MEMORANDUM

SUBJECT: Preliminary Site & Development Review for Property Located at 1501 Indian Rocks Road, and Application for Variances to the Following: Yard Setback Requirements; Landscape Buffer and Tree Mitigation; Joint Use Parking and Off-Street Loading Zones, By Pelican Golf Club LLC (Dan Doyle), on behalf of the Town of Belleair (Owner)

DATE: April 4, 2017

FIGURE 4. LANDSCAPE STANDARD A

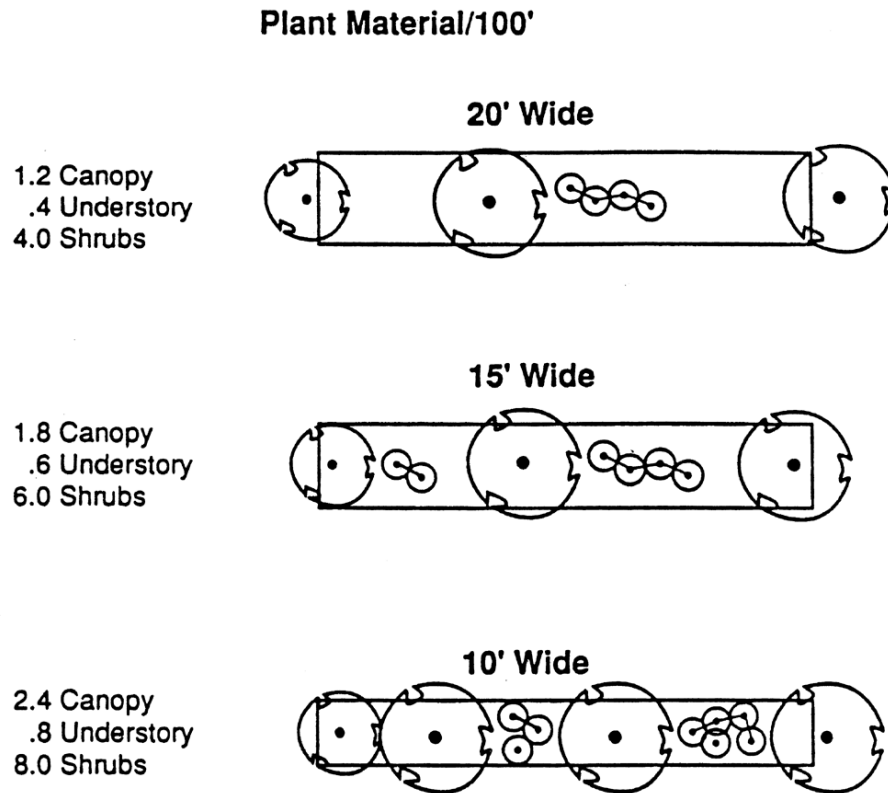
Golf course structures (GC) abutting R-1, RM-15 and P zoning districts shall adhere to landscape standard "A", as illustrated below. The applicant's redevelopment proposal for the "Golf Club parcel" meets the requirements for buffering. Although the applicant intends to preserve all vegetation along the project boundaries and adjacent to residential properties, the remainder of the golf course would not meet the buffer requirements in some areas. Strict interpretation of the Code requirement could effectively create a visual screen between the golf course and the surrounding residential properties.

Additionally, the variance must include the areas where the applicant believes that that "intent of the buffer requirements" is being met. The intent of the code as it specifically relates to landscaping is found in 66-6 (3), which has been attached. Staff also feels that it is important to consider that in some cases the cart path has

been moved closer to the border between the course and the homes along the course, which may increase cart golf traffic at a closer proximity to those homes.

The applicant is therefore requesting a variance to the landscape buffer requirements Section 74-232(b)(4), for those areas of the golf course that currently do not meet the requirement. It is again recommended that the commission consider Policy 1.1.4 of the Future Land Use Element of the Comprehensive Plan, which speaks to the need to provide adequate and appropriate buffering between land uses. Please refer to the applicant's justification for the variance.
